3.1 Proposals on improving traffic clearance data flow

In support of IALA G1128 applications and the implementation of digital maritime services (MS), in December 2022, MSC106 approved the Revised Electronic Chart Display and Information System (ECDIS) Performance Standard (MSC.530(106)), which introduced the Proposals on the "Service Specification for VTS Traffic Clearance Service Edition 1.0"

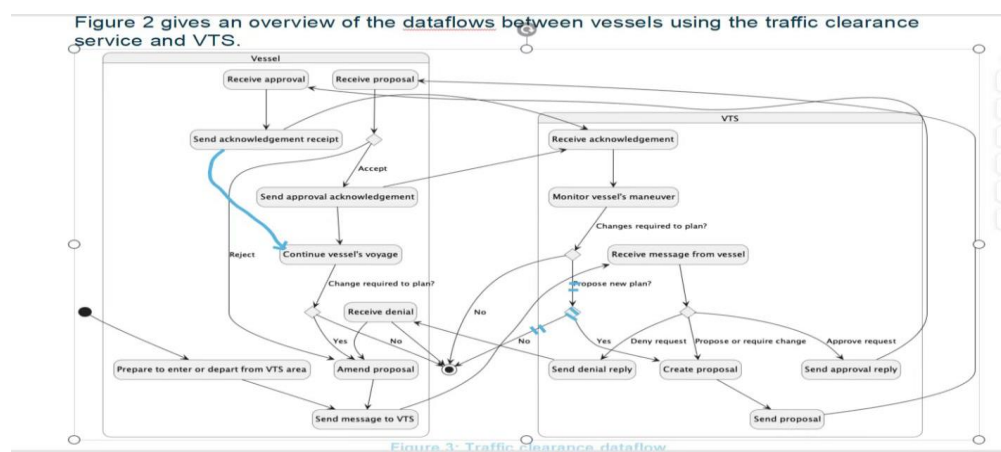
In the traffic clearance data flow (Figure 2 in Chapter 3.1), after vessels sending acknowledgement receipt, the next process should be "Continue vessel's voyage". When VTS monitors vessel's maneuver after receiving acknowledgement, the discussion on whether to change required to plan is too complicated, so it is recommended to keep "NO" or "YES". "NO" points to the end, and "YES" points to "Create proposal." The details are shown in the following figure:
